DATE: 02.18.2015
TO: ProTrak
FROM: Bill McDow
 Transportation Planning

■ **BRAGG ROAD DEVELOPMENT COMPANY [TRC Plan Review]**

↻ Initial Review Note ↻

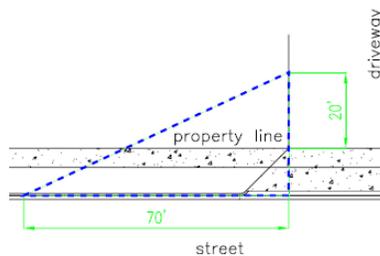
1. Traffic Engineering’s stance on sites that interconnect along a major thoroughfare is that the combined frontage must meet all driveway spacing requirements per the City’s technical standards.

- The proposed College Rd driveway does not have the 75' offset from property lines to the curb line required for lots along major thoroughfares. The spacing for this driveway is too close to the Bank of America Driveway.
